TO: Historic Preservation Board

FROM: Department of Doing, Planning Staff

DATE: December 05, 2017

SUBJECT: Petition HP-17-64. Tyler Sterrett, owner. Application for Certificate of Appropriateness for window and garage door replacement. Located at 416 NE 10th Avenue. The property is contributing to the Northeast Residential Historic District.

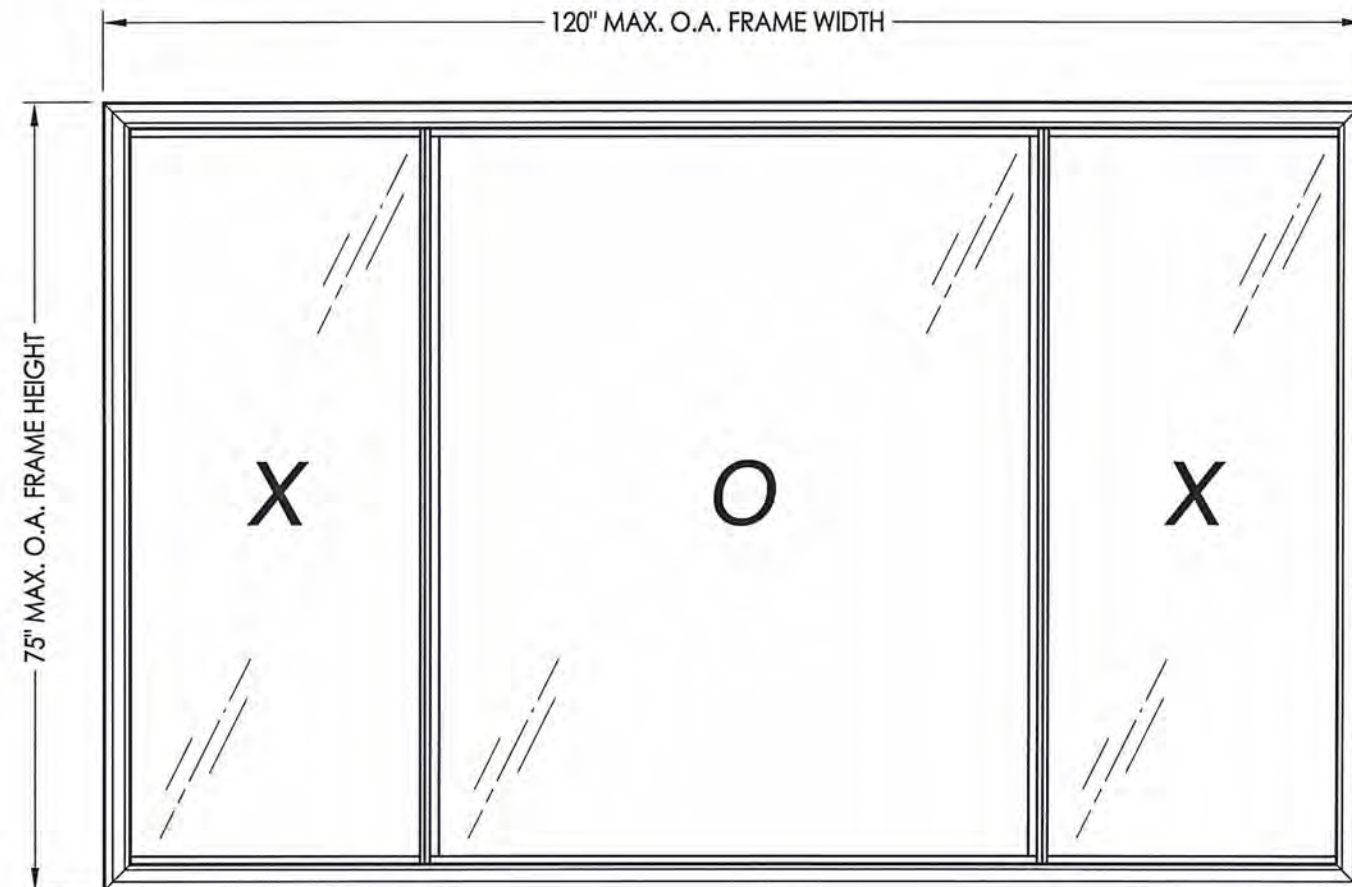
NE 10th Avenue (south facade) (top) and NE 5th Street (east façade) (bottom)

NE 10th Avenue windows: (Top) three jalousies will be replaced with a center fixed window and flanking sliders. (Bottom) to be replaced with a center picture window with flanking casements.

(Top): West façade, not visible. Three jalousie windows to be replaced with one fixed window and two flanking slider window. (Bottom): Fifth Avenue Façade. Two three jalousie windows will be replaced with one center, fixed window and two flanking casements,

Rear facades of house. These windows are not visible from the street.
(Top): double jalousie windows to be replaced with one fixed and one slider window. Jalousie
sidelights by the door will be replaced with either a fixed or casement window.

Rear facades of house. These windows are not visible from the street.

(Top): Four jalousie windows to be replaced with one fixed windows and two flanking slider window. (Bottom): Bathroom window will require operation for ventilation, will be a slider.

Garage door: existing (top) and proposed (bottom).

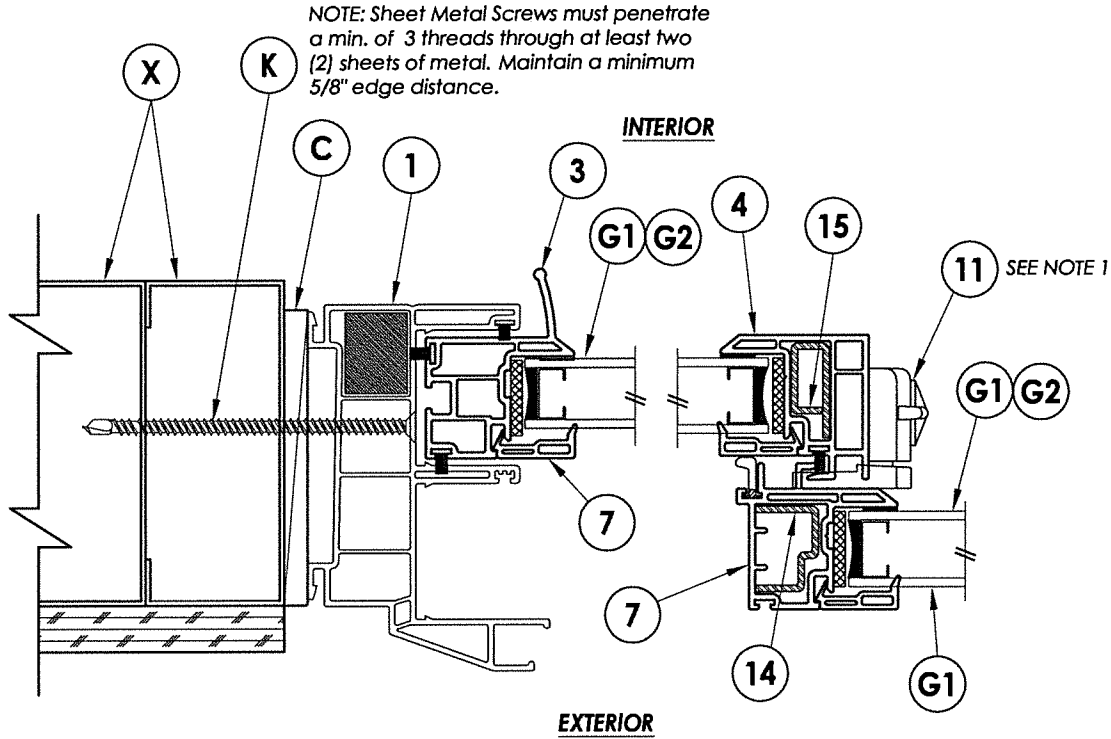
Replace missing or deteriorated doors with doors that match the original, or that are of compatible contemporary design. Staff does not find the existing garage doors to be a character-defining feature of the house. Staff finds the proposed doors a compatible contemporary design.
